### **REMARKS**

Response to Official Action  
Application No. 10/761,975  
Page 16

**Amendments to the Drawings:**

Fig. 3

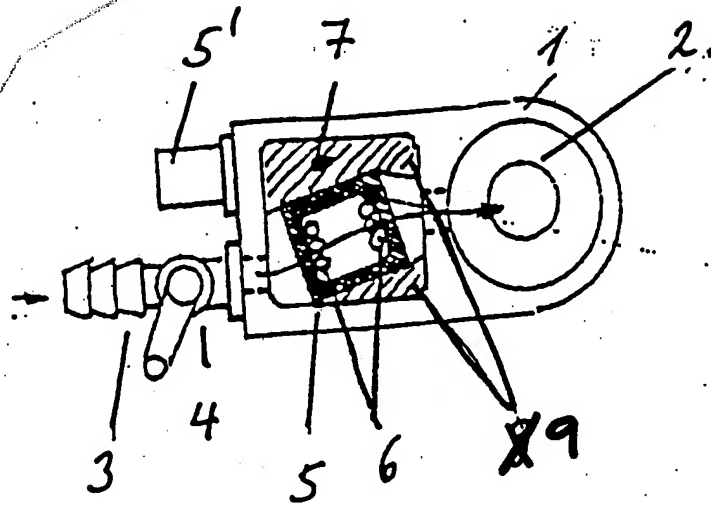
The attached sheet of drawings includes changes to Figures 3, 4 and 5. This sheet, which includes Figures 3, 4 and 5, replaces the original sheet including Figures 3, 4 and 5. A sheet showing the changes made to the drawings is also included herewith.

Fig. 5

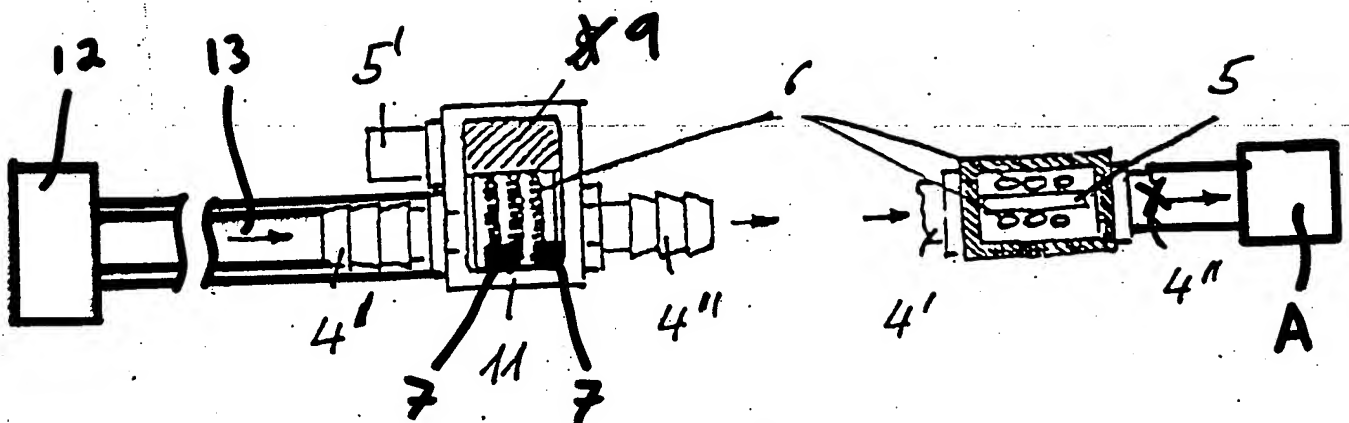
The drawings are also objected to under 37 CFR 1.83(a) as not showing every feature of the invention specified in the claims. Specifically, the Examiner has objected to the two temperature sensors 7 and the first instrument A not being

shown in Figure 5. Figure 5 has been amended to show these elements, and Paragraph [0038] of the specification is amended accordingly. Applicant respectfully submits that no new matter is being added.

Figure 5 has also been amended to show the insufflation device 12 and the tube 13 connecting the insufflation device 12 to the second instrument, since these elements are being added to Claims 1 and 14 by the Amendments presented herein. Paragraph [0033] is also being amended accordingly. Applicant respectfully submits that no new matter is being added, as these elements are disclosed, among other places, in Paragraphs [0014] and [0033] of the specification as originally filed.
